Office Action Summary	Application No. 10/573,057	Applicant(s) WILSON, DAVID	
	Examiner COREY HALL	Art Unit 3743

DETAILED ACTION

Figure A.

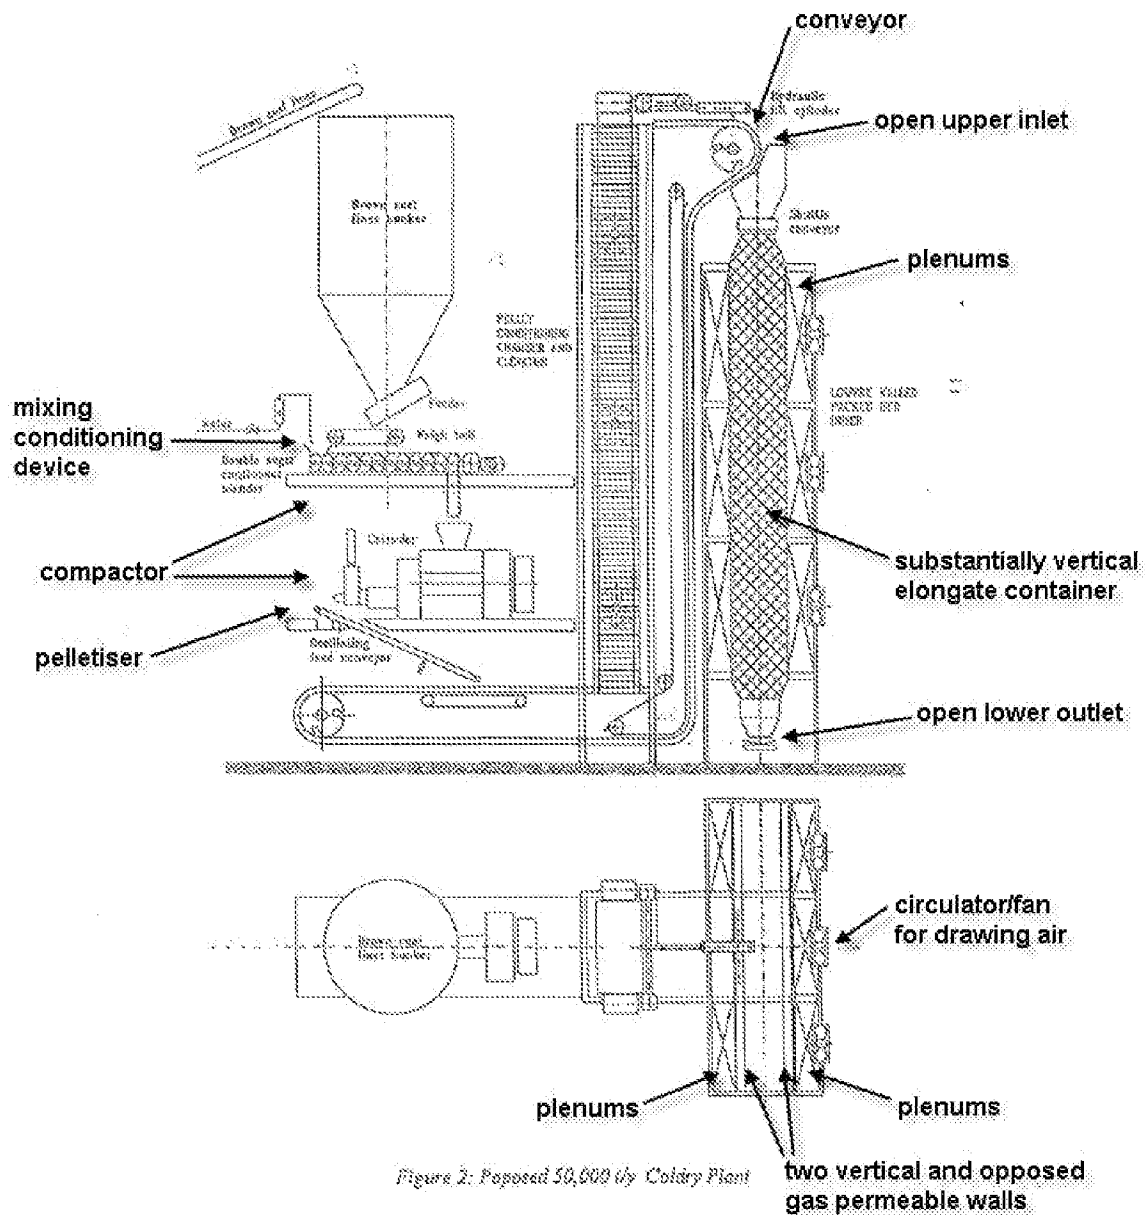
11. Regarding claims 1, 4-9, 11-13, 17-19, 21, and 24, Wilson et al. discloses a dryer (fig. 2) for drying pellets containing brown coal (page 3, line 3-page 4, line 13 describing a dryer for drying brown coal pellets), comprising at least one substantially vertical elongate container (fig. 2 and Figure A below) having: an open upper inlet (fig. 2 and Figure A below) for receiving a charge of moisture and the brown coal containing pellets (fig. 2 and Figure A below showing an open upper inlet of the dryer for receiving moist brown coal pellets, page 3, line 3-page 4, line 13 describing drying moist brown coal pellets); an open lower outlet (fig. 2 and Figure A below) for discharging dried brown coal containing pellets (“Dried pellets are extracted from the bottom” page 4, lines 1-2), whereby said pellets travel under the influence of gravity from said open upper inlet (fig. 2 and Figure A below) to said open lower outlet (fig. 2 and Figure A below) in a substantially continuous manner (“slowly descending mass of pellets” page 4, lines 1-13); two substantially vertical and opposed gas permeable walls (fig. 2 and Figure A below) through which a drying gas at temperatures from about 15°C to about 80°C (page 5, lines 13-23 describing drying at ambient temperatures or a few degrees higher where Applicant's specification discloses that the air temperature between about 15°C to about 80°C includes air at ambient temperature at page 10, lines 12-15) can pass to contact said pellets (“dried by means of a crossflow of air” page 3, line 31-page 4, line 13); . . . ; said dryer also comprising plenums (fig. 2 and Figure A below) on exterior surfaces of said gas permeable walls (fig. 2 and Figure A below), wherein the plenums (fig. 2 and Figure A below showing plenums divided into zones) are divided into zones . . . , wherein ingress openings and egress openings (“long vertical walls,

which are perforated” page 4, lines 1-4 describing a crossflow of air passing through the perforated walls) are respectively provided within said gas permeable walls (fig. 2 and Figure A below), wherein a plenum (fig. 2 and Figure A below showing plenums on the left side of the container where the plenums on the right show fans used to draw the drying air) covering said ingress openings comprises at least one inlet (“Drying air enters at one side, is drawn through the slowly descending mass of pellets, and discharged from the opposite side” page 4, lines 4-5 where it is implicit that the plenums on the left side would have at least one air inlet) and a plenum (fig. 2 and Figure A below showing plenums on the right side of the container) covering egress openings comprises at least one outlet (“discharged from the opposite side” page 4, lines 4-5 where it is implicit that the plenums on the right side would have at least one air outlet), wherein drying gas is drawn (“Drying air . . . is drawn through the slowly descending mass of pellets” page 4, lines 4-5) into the at least one inlet by a circulator (fig. 2 and Figure A below), wherein the circulator is an induced draft fan (fig. 2 and Figure A below, “Drying air . . . is drawn” page 4, lines 4-5), a drying plant (fig. 2, “plant layout in Fig. 2” page 4, lines 3-13) comprising: (a) a conditioning bed (“Pellet Conditioning Chamber and Elevator” fig. 2, page 3, lines 17-23 describing surface conditioning moist brown coal pellets in an elevating tray system where the trays would form a bed of pellets for conditioning) for subjecting moisture and brown coal containing pellets to surface conditioning; (b) at least one conveyer (fig. 2 and Figure A below) for conveying said surface conditioned brown coal containing pellets to the open upper inlet (fig. 2 and Figure A below) of a dryer according to claim 1; . . . , further comprising a compactor (fig. 2 and Figure A below) for production of brown coal containing compacted bodies (page 3, lines 3-16 describing compacting brown coal into pellets), wherein the

17. Regarding claims 20 and 25, Wilson et al. discloses a dryer (fig. 2) for drying pellets containing brown coal (page 3, line 3-page 4, line 13 describing a dryer for drying brown coal pellets) comprising at least one substantially vertical elongate container (fig. 2 and Figure A below) having: an open upper inlet (fig. 2 and Figure A below) for receiving a charge of brown coal pellets (fig. 2 and Figure A below showing an open upper inlet of the dryer for receiving moist brown coal pellets, page 3, line 3-page 4, line 13 describing drying moist brown coal pellets); an open lower outlet (fig. 2 and Figure A below) for discharging dried pellets (“Dried pellets are extracted from the bottom” page 4, lines 1-2), whereby said pellets travel under the influence of gravity from said inlet (fig. 2 and Figure A below) to said outlet (fig. 2 and Figure A below) in a substantially continuous manner (“slowly descending mass of pellets” page 4, lines 1-13); two opposing substantially vertical gas permeable walls (fig. 2 and Figure A below) through which a drying gas at temperatures of from about 15°C to about 80°C (page 5, lines 13-23 describing drying at ambient temperatures or a few degrees higher where Applicant's specification discloses that the air temperature between about 15°C to about 80°C includes air at ambient temperature at page 10, lines 12-15) can pass to contact said pellets (“dried by means of a crossflow of air” page 3, line 31-page 4, line 13); . . . ; said dryer also comprising plenums (fig.

2 and Figure A below) on external surfaces of the gas permeable walls (fig. 2 and Figure A below), wherein the plenums (fig. 2 and Figure A below showing plenums divided into zones) are divided into zones . . . , and wherein said plenums (fig. 2 and Figure A below) are located external to said substantially vertical elongate container (fig. 2 and Figure A below), except for wherein the gas permeable walls comprise a substantially continuous corrugated plate, wherein each corrugation comprises a supporting leg and a permeable leg angled with respect to each other, of differing air stream properties and wherein the direction of drying gas flow through the charge of brown coal containing pellets is reversed from one plenum zone to an adjacent plenum zone; the dryer comprising lateral internal membrane walls joining opposing gas permeable walls that divide the dryer into a plurality of adjacent cells. However, Pietsch teaches gas permeable walls (1, 2, fig. 1, page 1, lines 34-41 describing gas permeable walls 1 and 2) comprise a substantially continuous corrugated plate (figs. 1-3 showing the walls 1 and 2 as substantially continuous corrugated plates), wherein each corrugation comprises a supporting leg (fig. 3 showing a supporting leg at 2) and a permeable leg (fig. 3 showing a permeable leg with perforations 5 located below the supporting leg at 2) angled with respect to each other (fig. 3) in order to provide the perforated and substantially louvered shaped walls required by Wilson et al. (Wilson et al., page 4, lines 3-4) and to provide constant circulation of air through the walls from the downward movement of the material (Pietsch, page 1, lines 64-76). Therefore, it would have been obvious to one of ordinary skill in the art at the time of invention was made to modify the Wilson et al. reference, to include wherein the gas permeable walls comprise a substantially continuous corrugated plate, wherein each corrugation comprises a supporting leg and a permeable leg angled with respect to each other, as suggested and taught by Pietsch, for the
